Bulletin Number - BP2A - 01

Project	Steamboat I	Base Village Re	devel	opment		Date 05/26	/2021	
Project Location	Steamboat,	Colorado				Architect's Pro	ject Number 03.7	835.000
Owner/Client	Alterra Mour	ntain Company	/ Eas	t West Partners	S	File 6BL T	his is page 1 of	
То	Saunders Co	onstruction Inc.				Attention B	ryan Sculthorpe	
Address	86 Invernes	s Place North						
City	Englewood					State CO	Zip 80112 Code	
Delivered via:	П	Messenger	П	Hand carried	П	Facsimile		
Denvered via:		Express		Pick-up		E-mail Address		
		Mail		UPS		Website Address	BIM360	
This Bulletin Convey	s to Contractor (Check one of the fo	ollowing	g five choices.):				
Architect's Author		or Changes to the Work as des	cribed	below.				
		mental Instruction				, ,	ntal Instructions form	•)
Architect's Confir This confirms Archi Note: The above the is/are issued in acco	tect's verbal instr ree choices are ea	ructions to (individu ach subject to the fo	al's nar ollowing	me) on (date g terms: The change	e), a: e(s), clarific	s described below. ation(s) and/or confir	mation(s) described b	RCRBI

General: This bulletin addresses clarifications to Gold Walk's door schedules, door hardware, and room numbering for pe

C.020

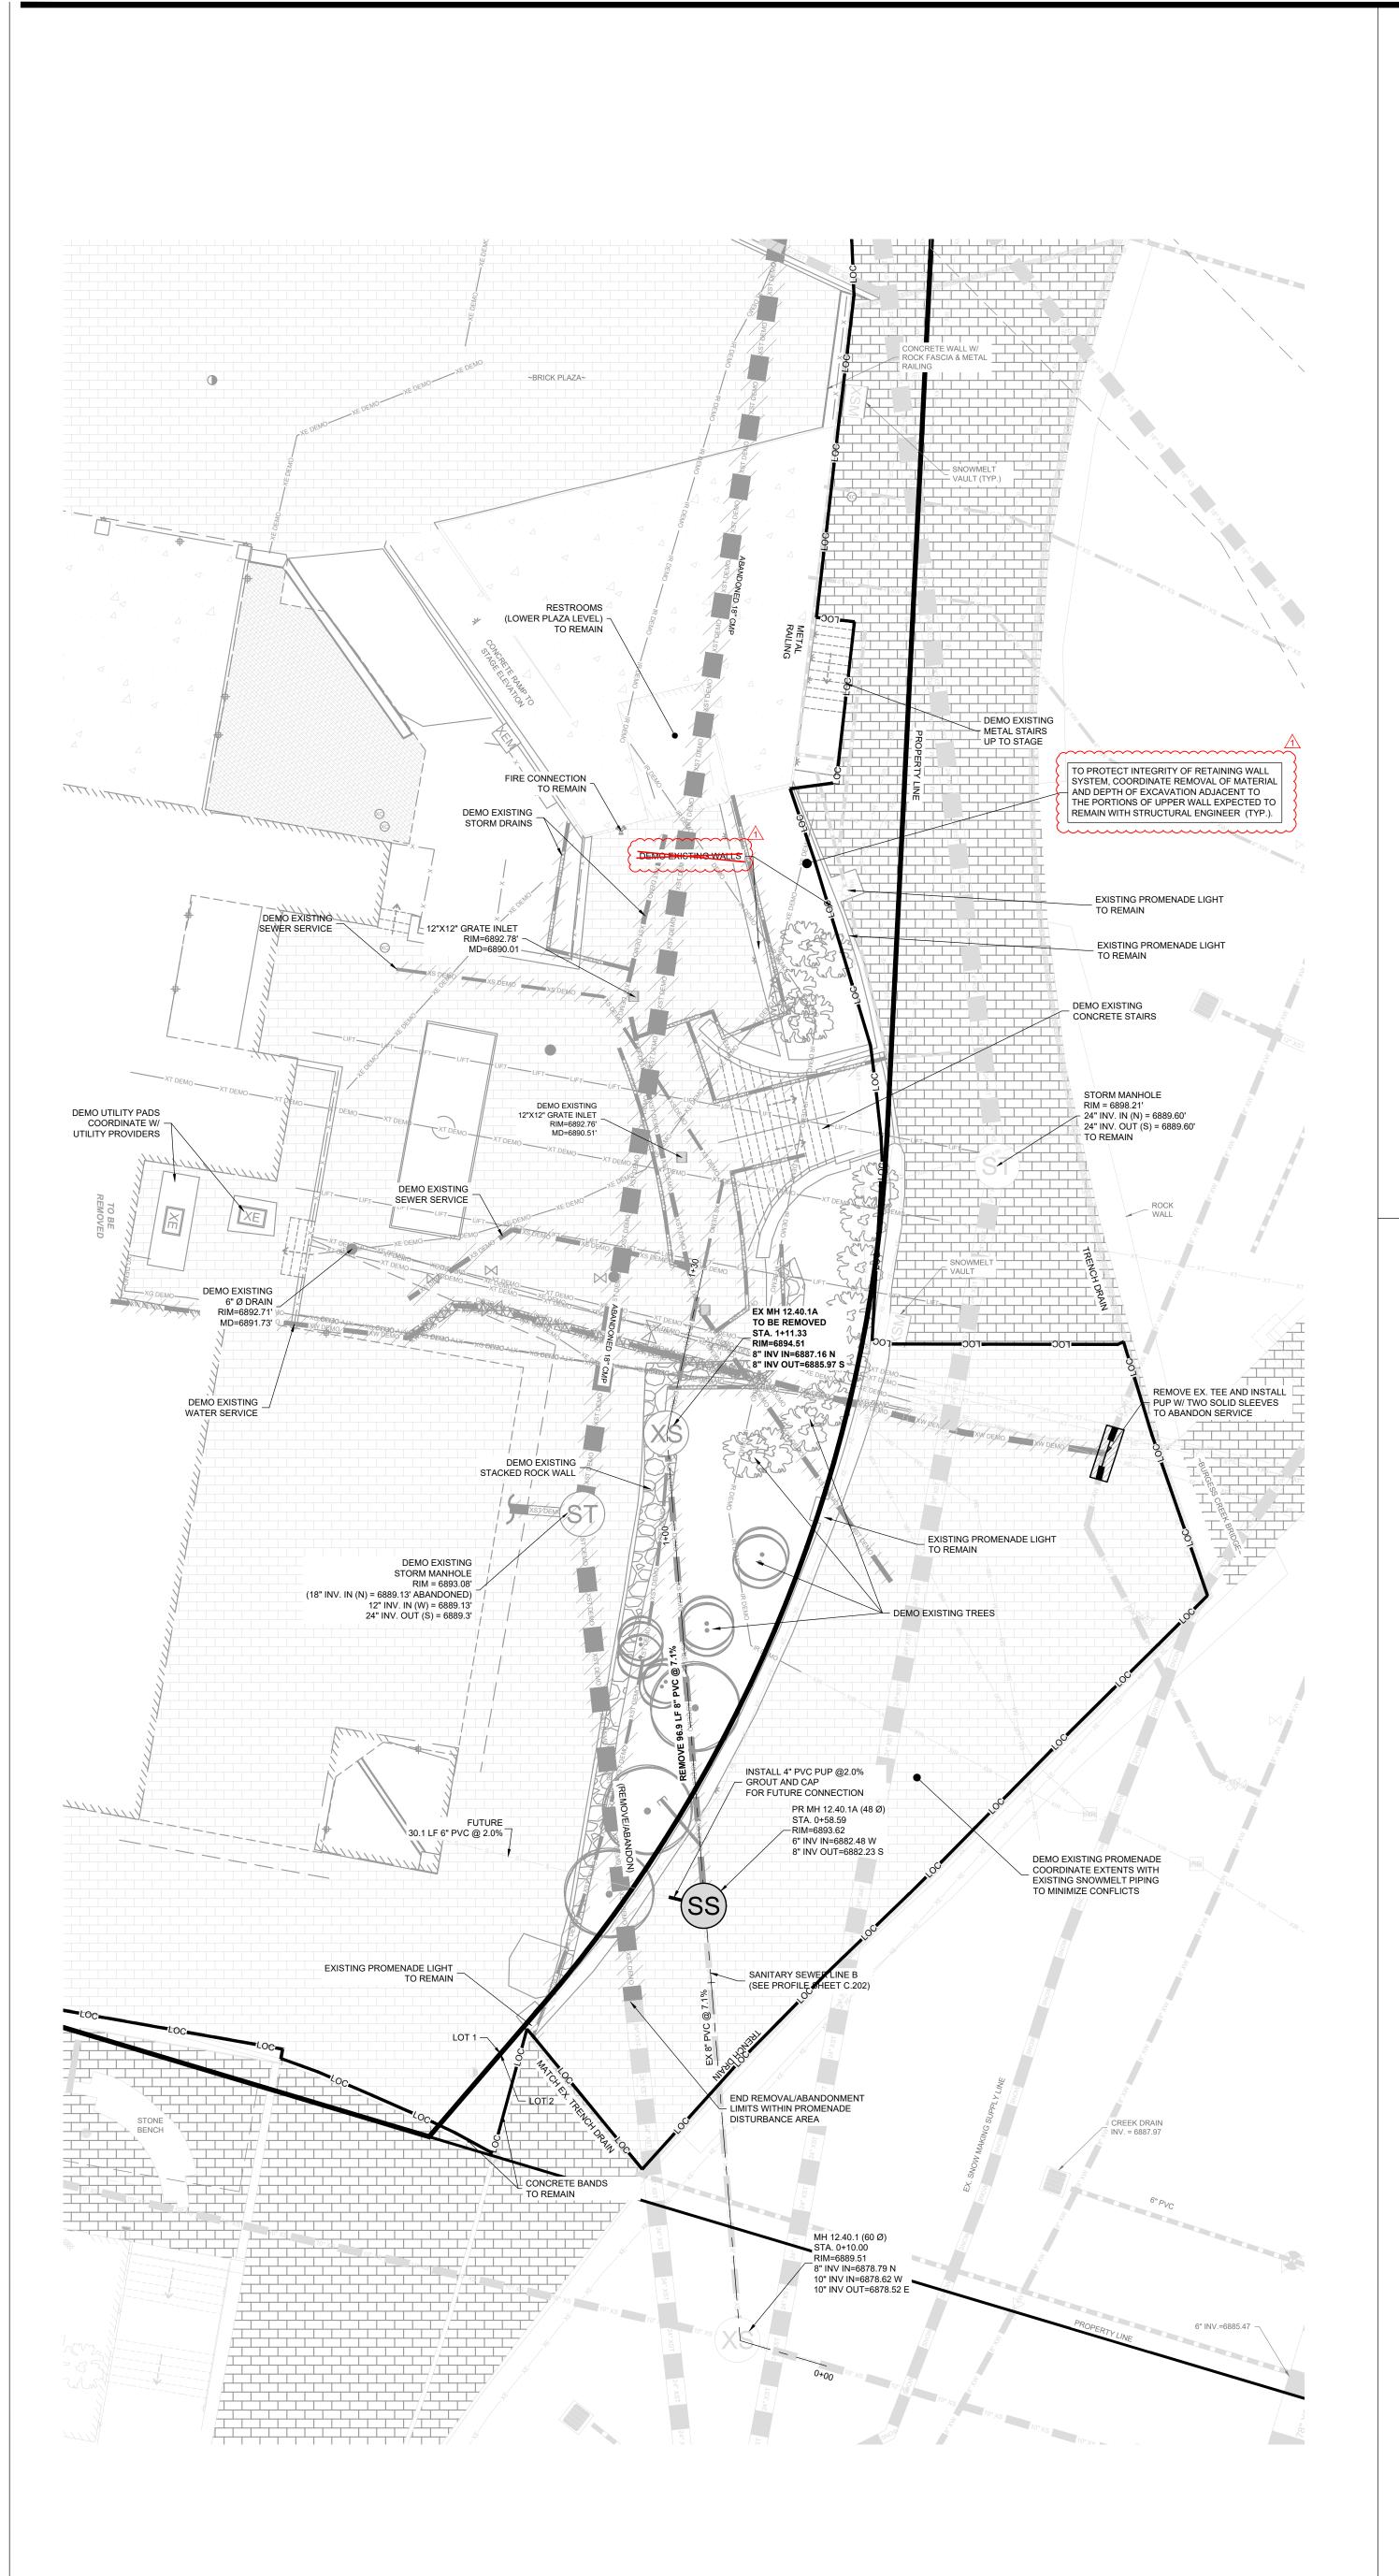
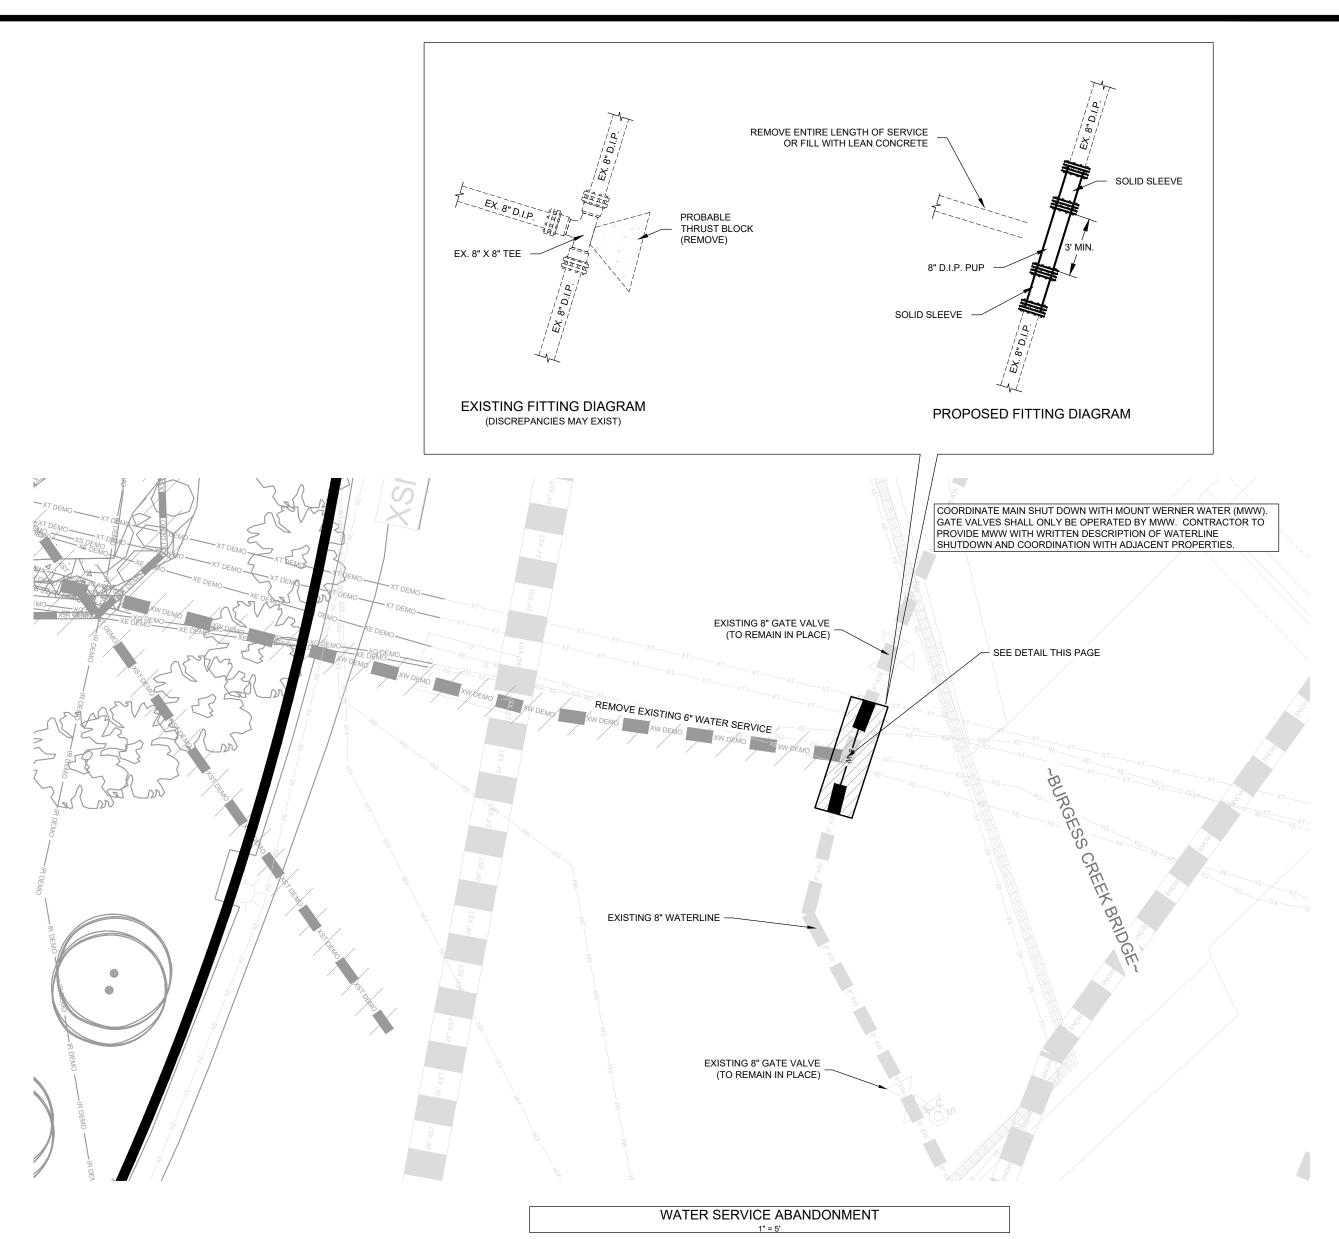
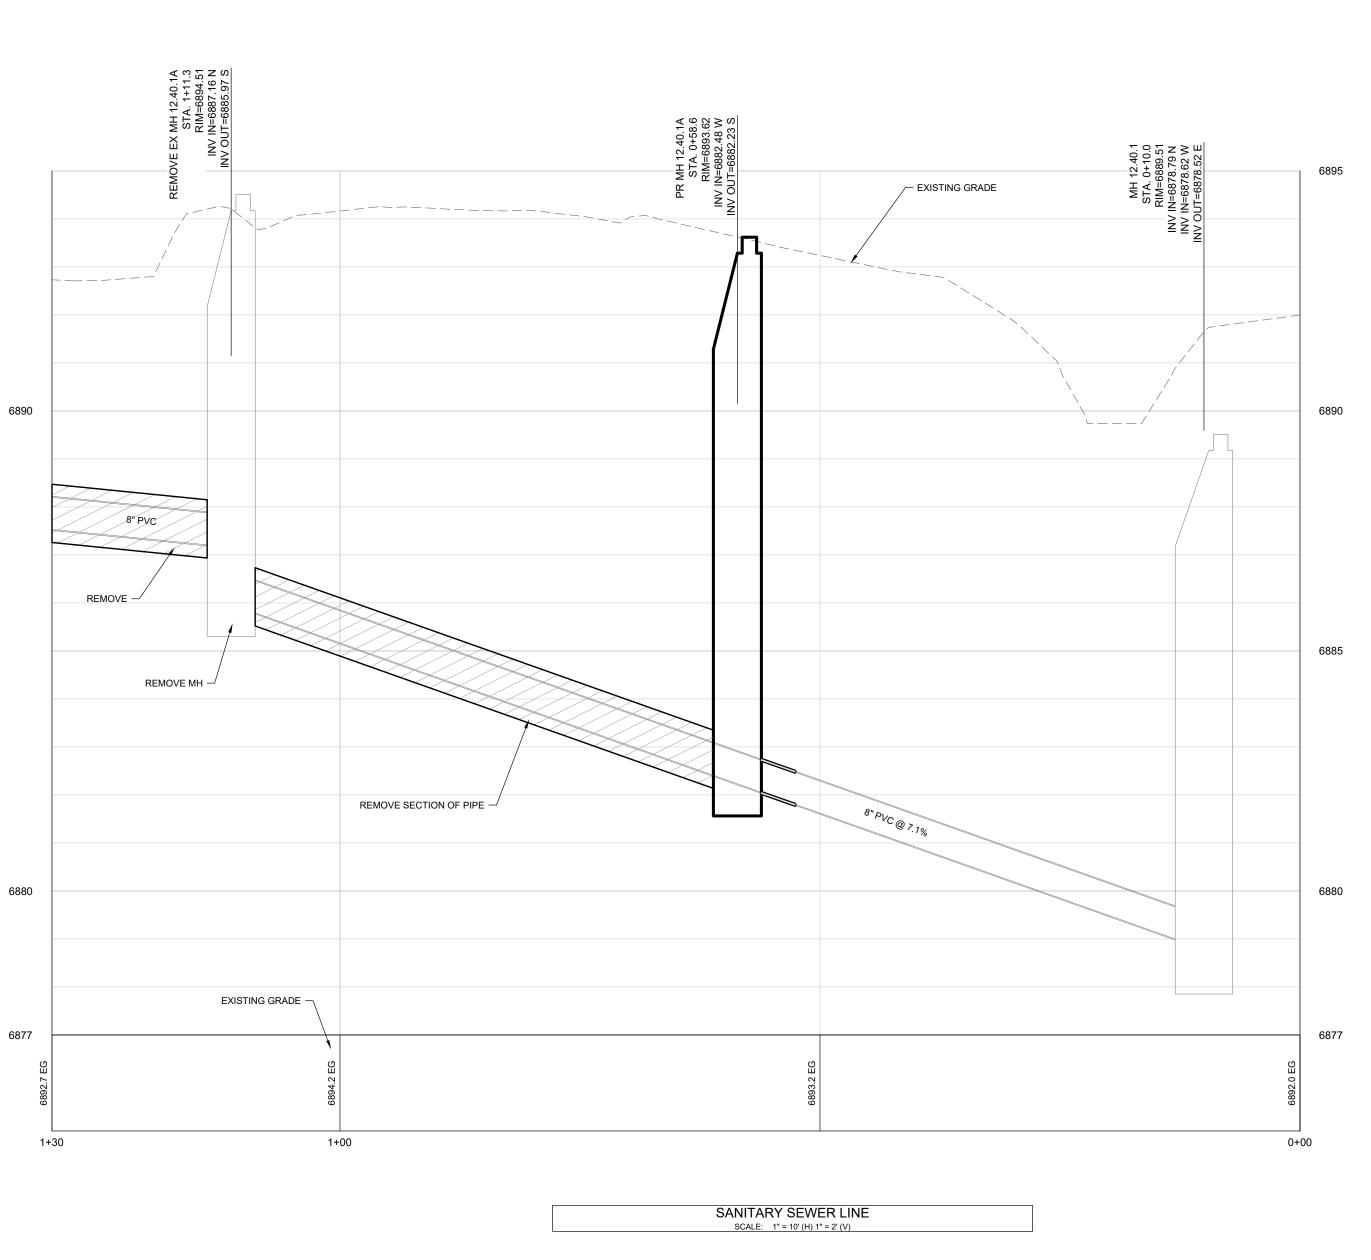
- 1. C.020 Civil Demolition Plan
 - a. The existing inlets and grates in the plaza were originally identified as 'to remain' based on the design direction during the original production. Some of the inlets now require grade adjustment and/or new inlets and pipe to jog around the future Building B.

- b. The Boiler Room sanitary sewer service is to be abandoned near SSMH 12.41.3. The Water District stipulated that this line be exposed and size, material and orientation evaluated for additional information regarding abandonment.

- c. The walls along the promenade near the bathrooms were originally identified as being removed. The direction from the Landscape Architect is that the upper wall (immediately adjacent to the Promenade) is to remain as practicable.

C.021

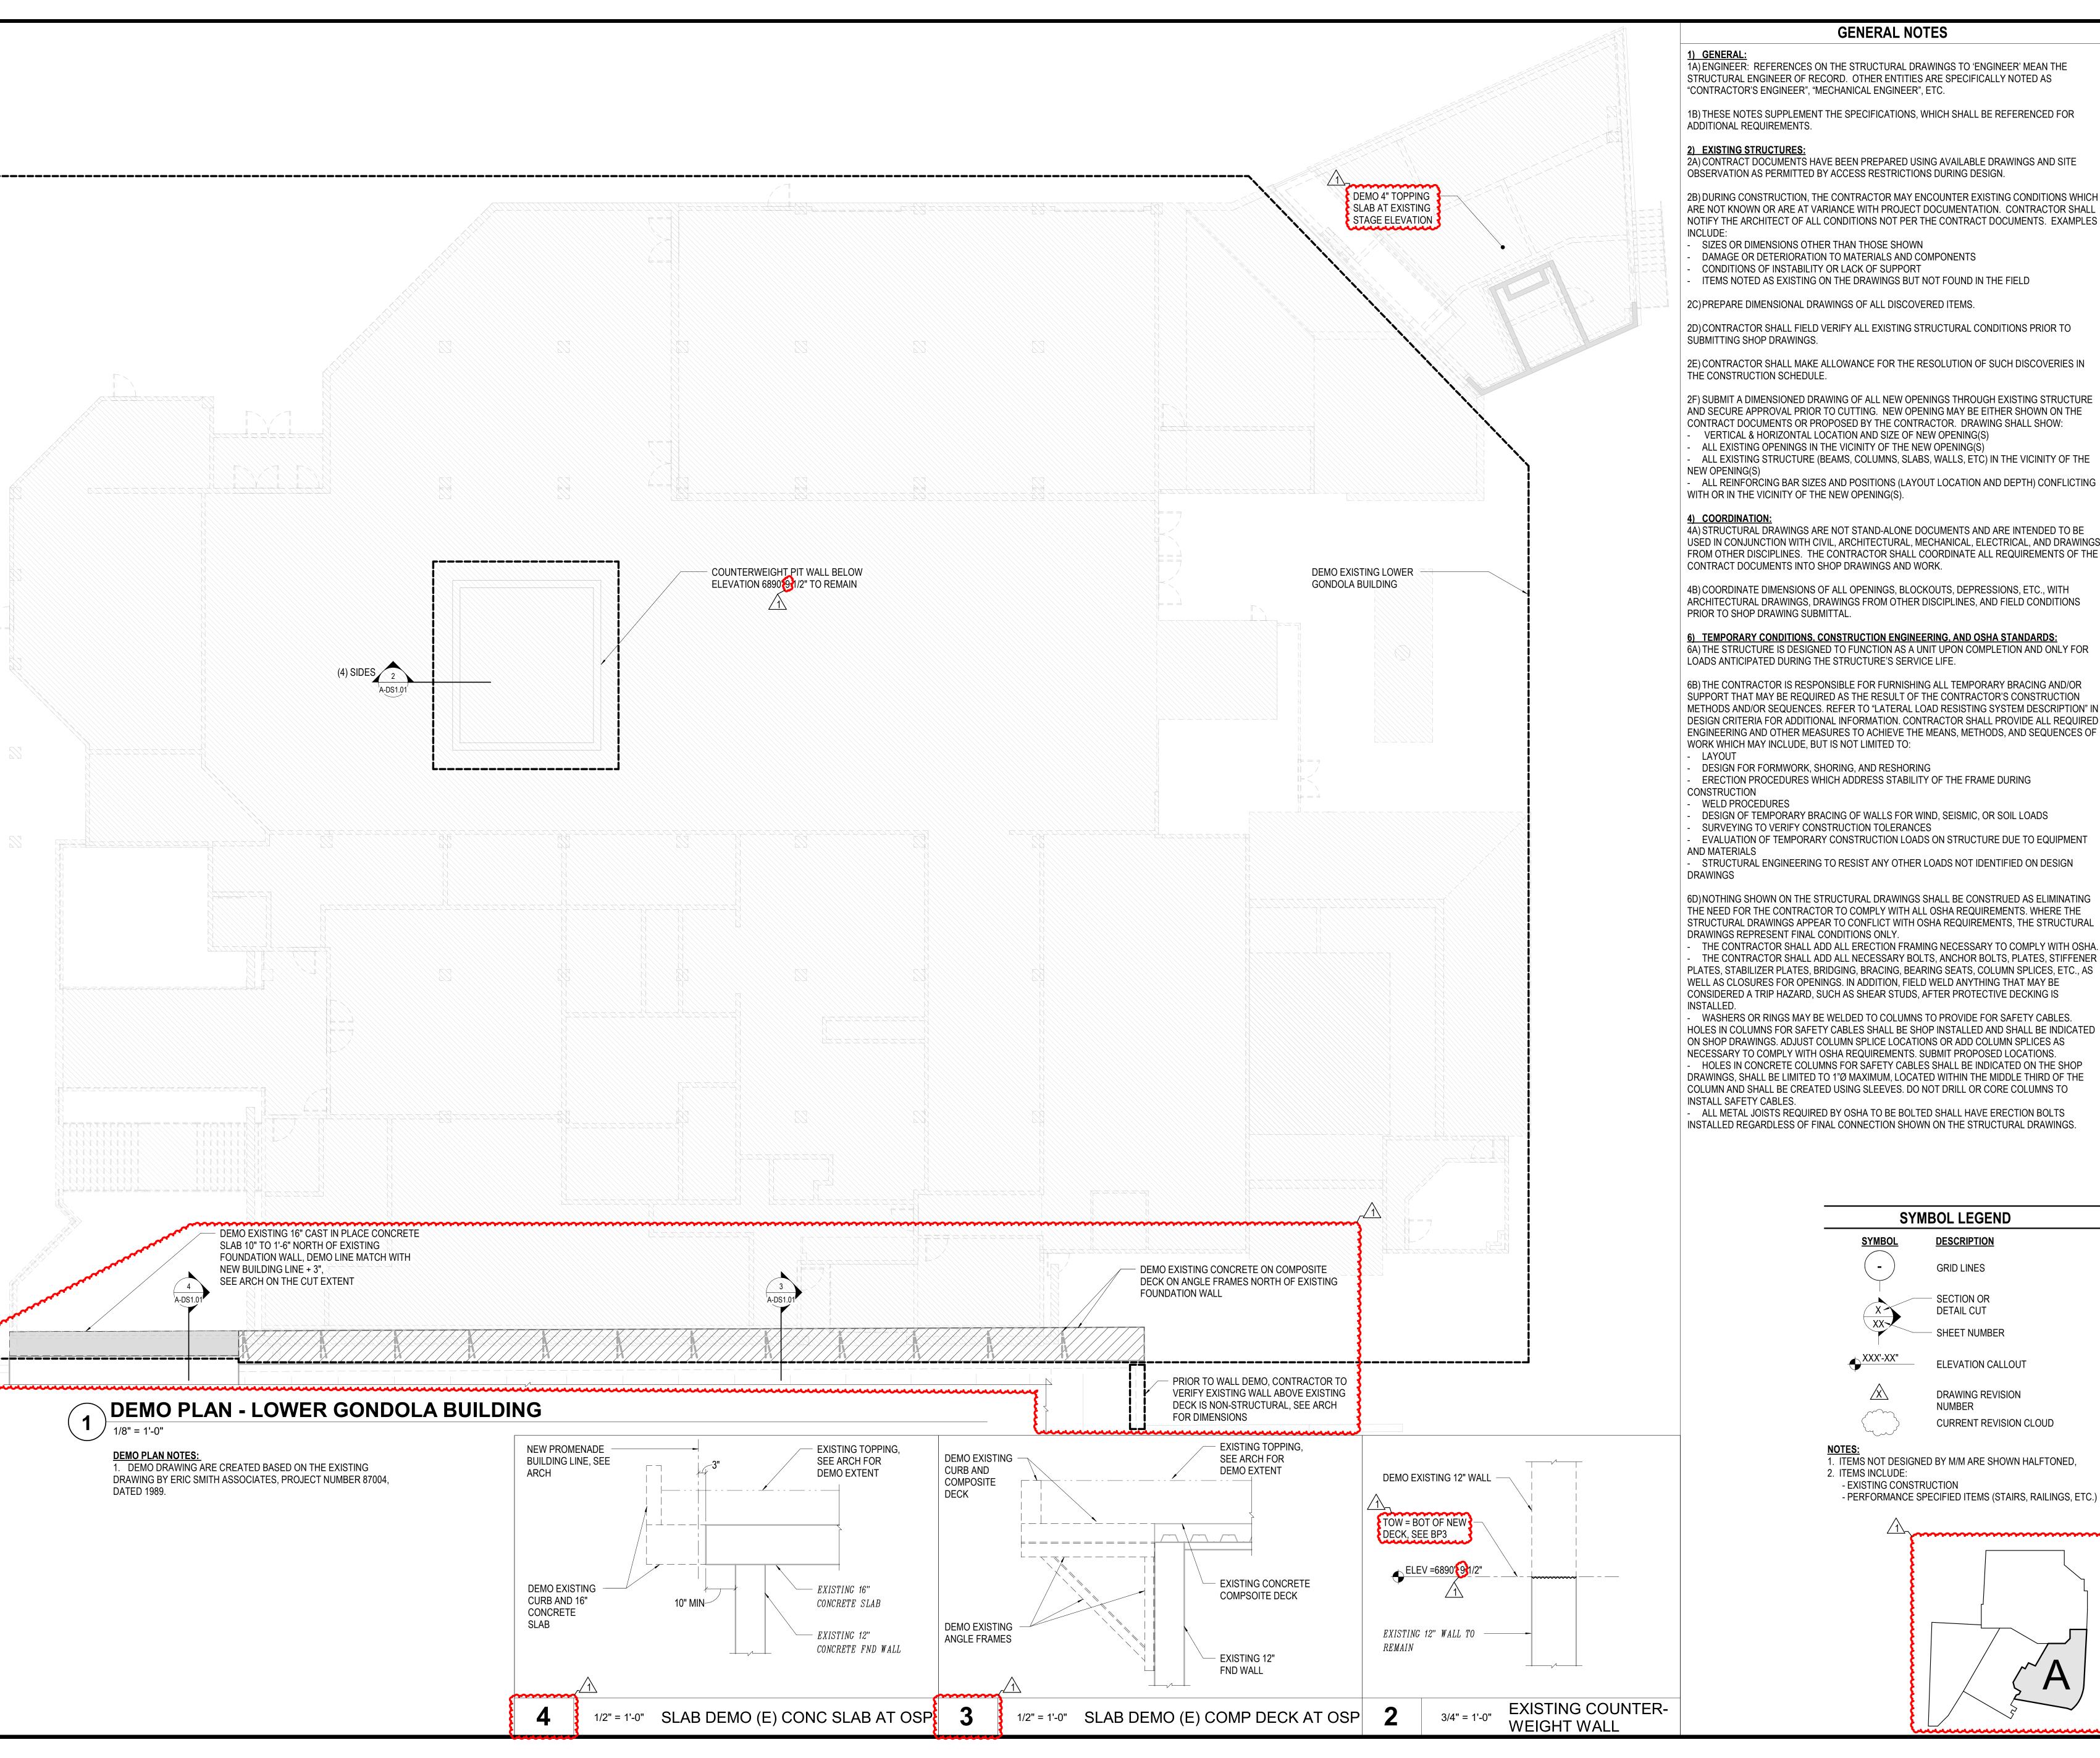
- 2. C.021 DETAILED CIVIL DEMOLITION PLAN
 - a. The walls along the promenade near the bathrooms were originally identified as being removed. The direction from the Landscape Architect is that the upper wall (immediately adjacent to the Promenade) is to remain as practicable.
